BRUNSWICK-GLYNN COUNTY JOINT WATER & SEWER COMMISSION

PROJECT: Invitation for Bid No. 20-024 – Academy Creek Warehouse
Roof Replacement for the BGJWSC

ADDENDUM: Three (3)

Questions

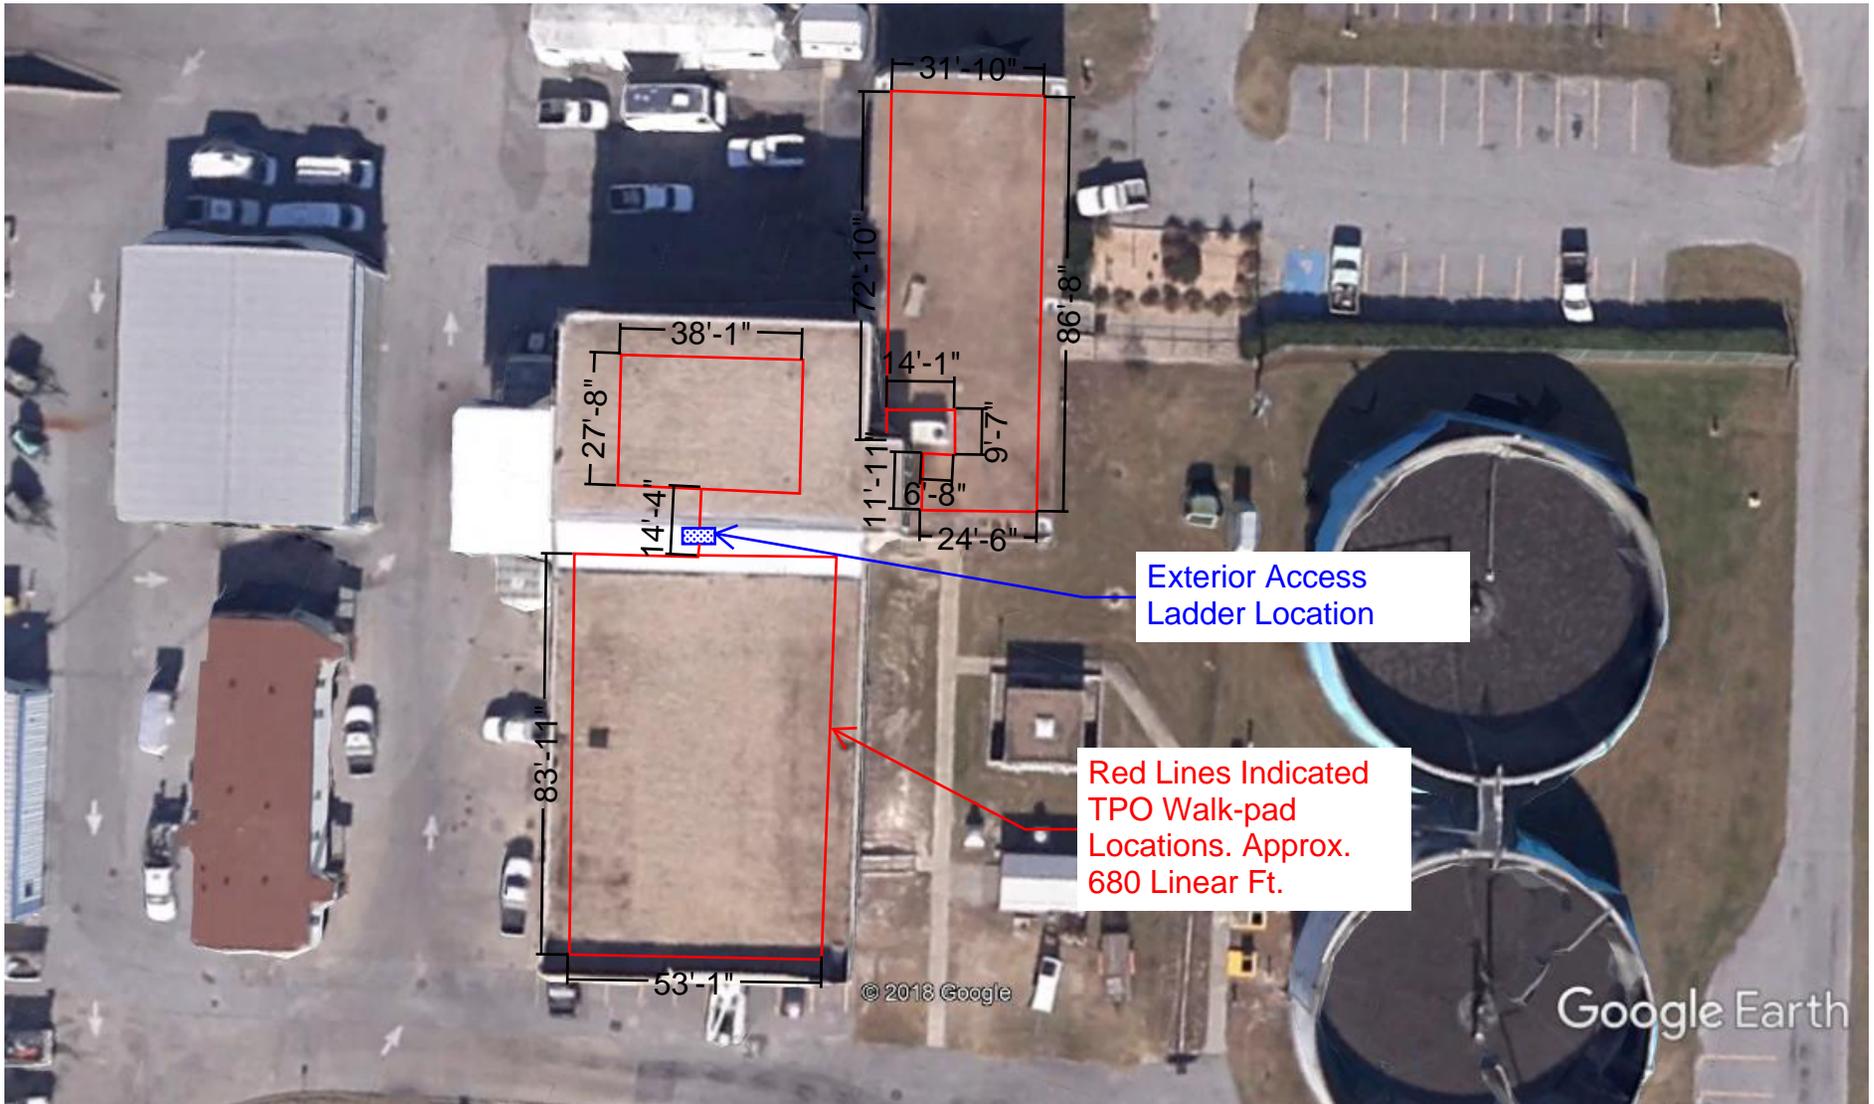
1. Are the TPO walk pads in the desired locations? 680 linear ft?
2. 2020 bldg code requires the roofing insulation be a R-25. Are we using a R-25 Polyisocyanurate Tapered Insulation System?
